Government of the District of Columbia
Department of Consumer and Regulatory Affairs

Office of the Zoning Administrator

Re: Cleveland Park -3407 34th Pl., NW – Lot 0078 in Square 2076

File: Det. Let. Re 3407 34th Pl., NW to Whitmore 3/17/20

1 Existing Site Plan
1/8" = 1'-0"

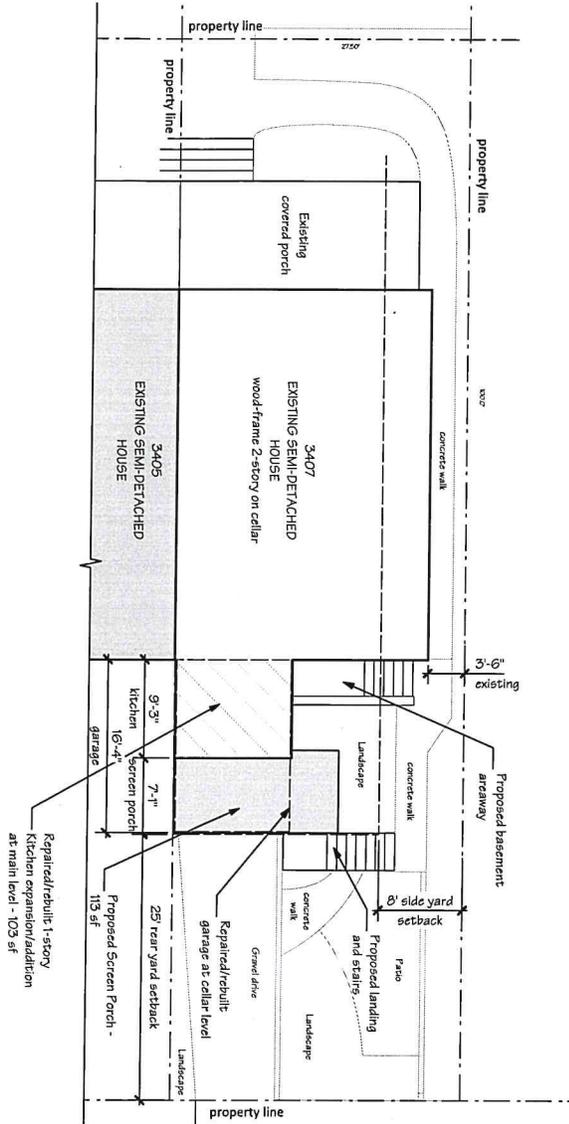
The current cellar-level garage extends 19.1' from the rear wall of the main residence, leaving an existing rear yard of 22.5'. You plan to reduce the depth of the garage, as it will be used for motorcycle storage, and will retain the existing complying parking space behind it. The proposed garage will leave a conforming 25' rear yard setback.

The current cellar-level garage extends 19.1' from the rear wall of the main residence, and the sunroom above extends about 9.3'. Even with the reduced depth of the replaced garage, it will extend 16.3' from the main rear wall of the neighboring property.

2 Proposed Site Plan
1/8" = 1'-0"

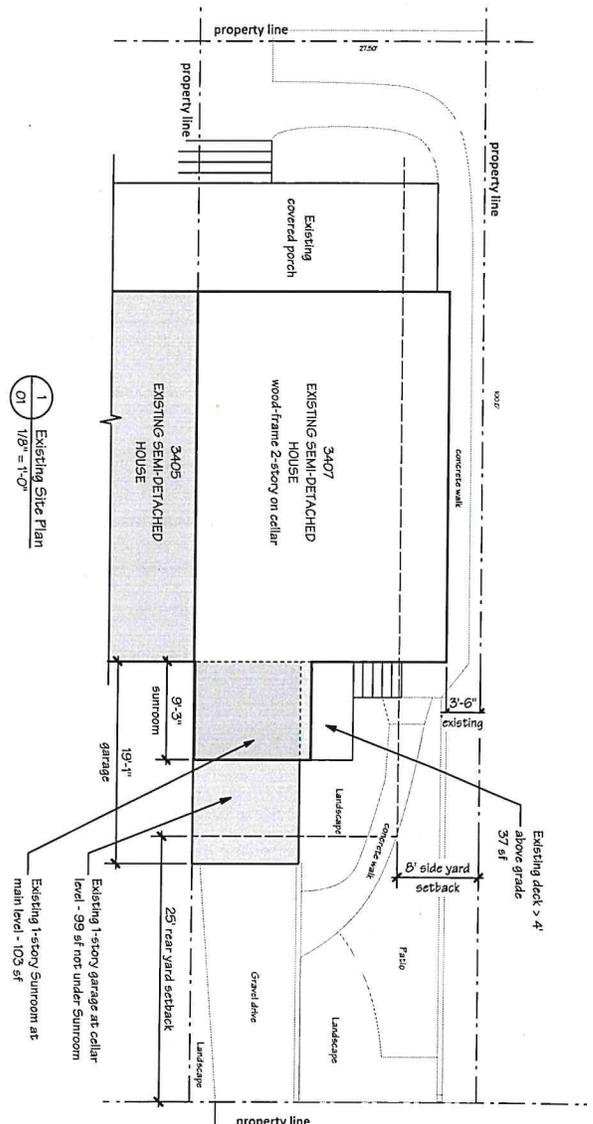
The existing house is of modest size, but because the lot is substandard at 2,750 sq. ft., the lot occupancy is over the allowed 40% maximum. The proposed reduction from 47.6% to 46.8% is allowed.

You are planning to add a screen porch which will cover the remaining part of the garage that isn't under the sunroom, plus it will extend to the side by an additional 35 square feet.

Per DCMR Subtitle D§306.3, an addition is allowed to extend 10' beyond this main rear wall for a new addition. The neighboring half of the semi-detached dwelling has no wall further back than the main rear wall. It does have an attached two-story porch that extends 7' from the rear wall, but you were advised during the PDRM that you must measure from the main rear wall.

The change in pervious area is mostly due to the planned areaway and stairs to the basement, along with a few changes to the concrete walkways. Most of the existing patio in the back yard will remain, along with most of the existing planting areas. Overall the pervious surface will be slight reduction from 23.6% to 23%.
